Enhancements in 9323 Series Transceivers

Scope

08-04966-001
Bottom View

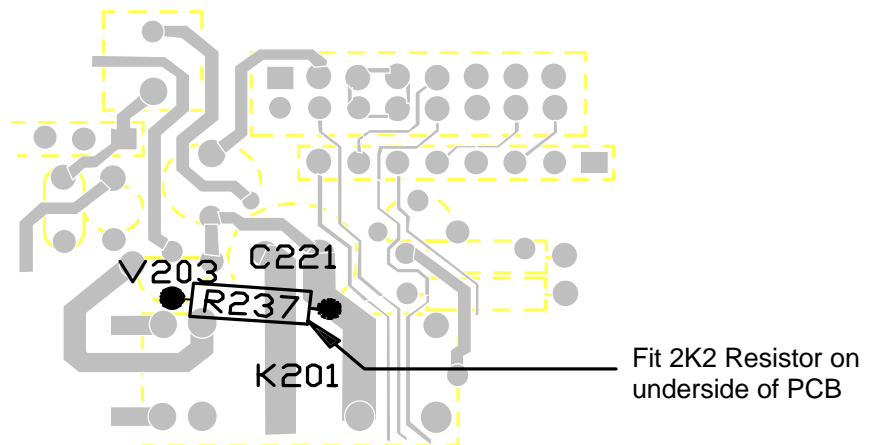
The transceiver turns itself ON and then may or may not be able to be turned OFF. This is caused by leakage in the power-on circuit and can be overcome by biasing V203 (the power-on transistor) off slightly so that it requires a greater base current to turn the transceiver ON.

The remedy requires the addition of a resistor on the Microprocessor & Audio PCB assembly, 08-04966-001. With the transceiver disconnected and removed from the installation, remove the bottom cover. Disconnect all the ribbon cables from the PCB taking careful note of the orientation of the connectors on P103 and P302. Remove the 7 cross head screws securing the PCB in place and withdraw the PCB. Identify V203, which is located at the right rear corner of the PCB (with the front panel towards you) adjacent to the relay K201. Fit a 2K2 resistor between the Base of V203 and relay K201, (Base-Emitter junction of V203), as shown below. This resistor can be added to any circuit diagrams that you may have, and be designated R237.

1 x 2K2 ohm CR25 resistor (Codan Part Number 40-32200-020).
